REMARKS

The present invention is directed to a thermal transfer roller having an outer cylindrical shell which contacts a substrate being heated or cooled, and an inner cylindrical shell which is coaxially positioned within the outer shell to define a continuous annulus between the inner cylindrical shell and the outer cylindrical shell through which heat transfer fluid may flow. A "continuous" annulus refers to an annulus having an uninterrupted or non-partitioned area in a circumferential direction, as shown in Fig. 1.

FIG. 2

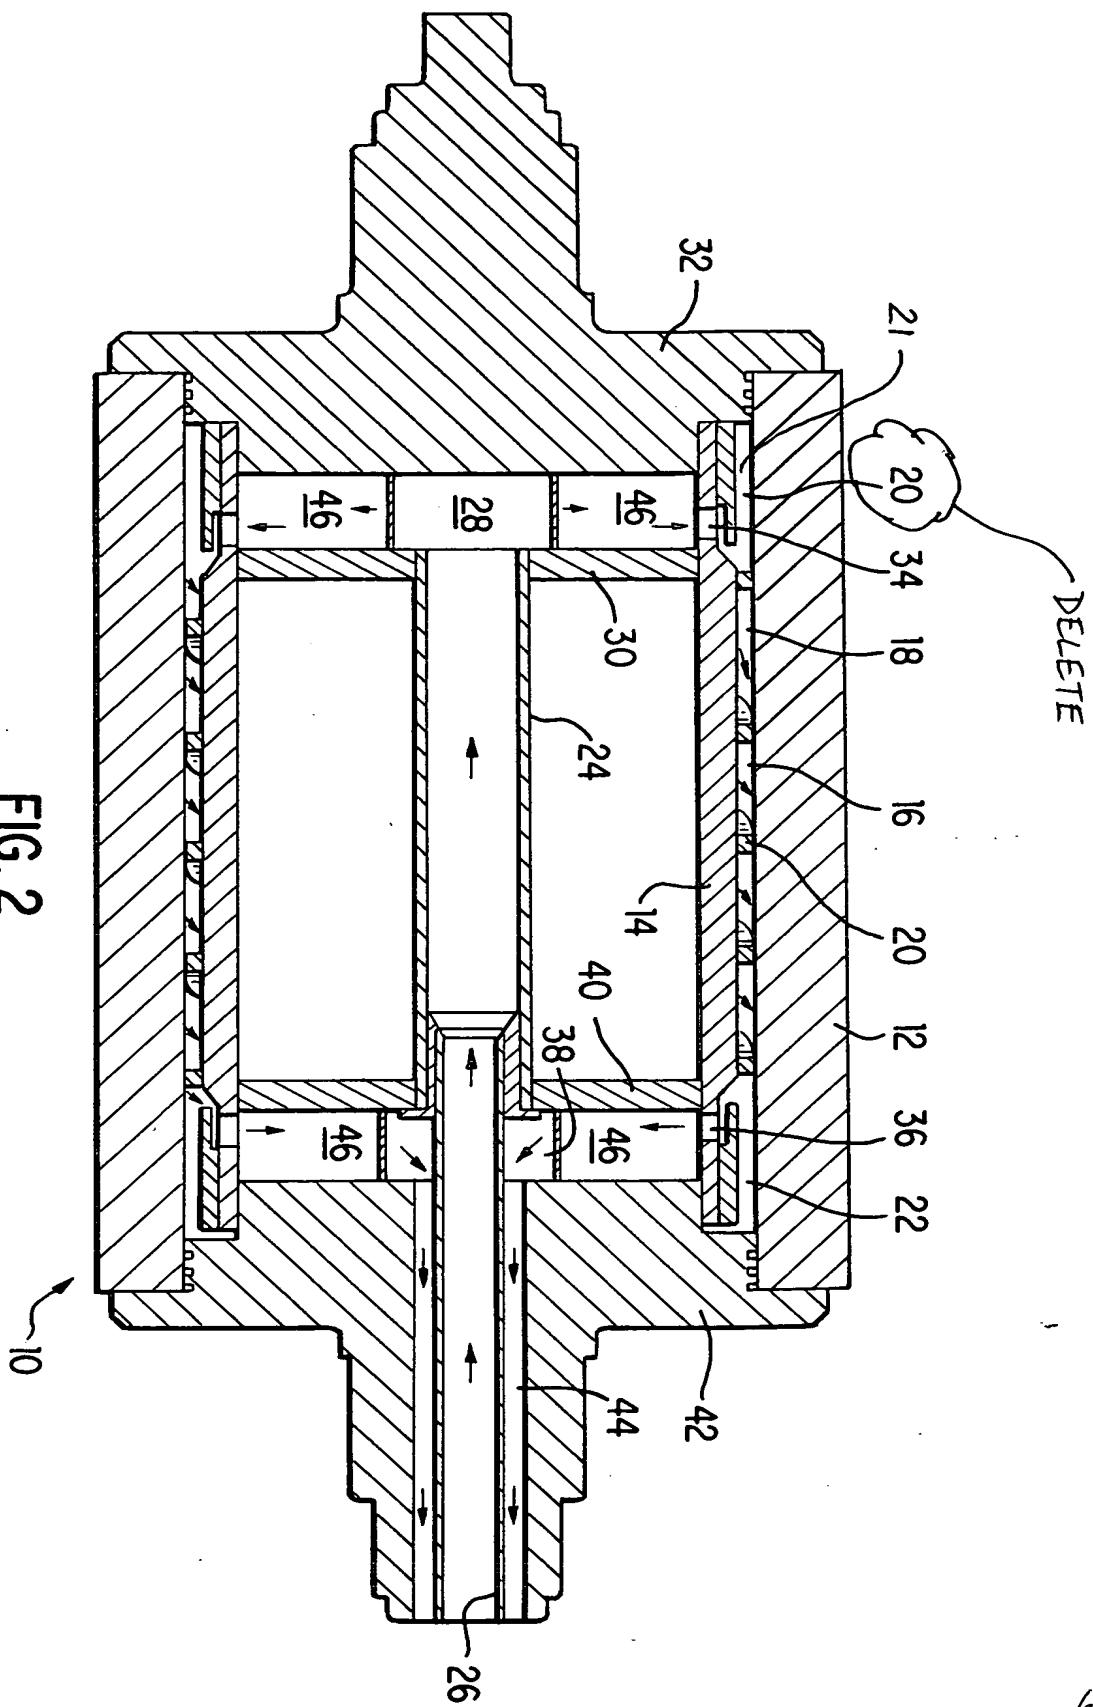
Applicants have amended Fig. 2 to consistently correspond to the specification as amended. The second occurrence of element reference number "20" was deleted and new element reference number "21" was added to reference the first (inlet) end.

Okay
as
6/26/01
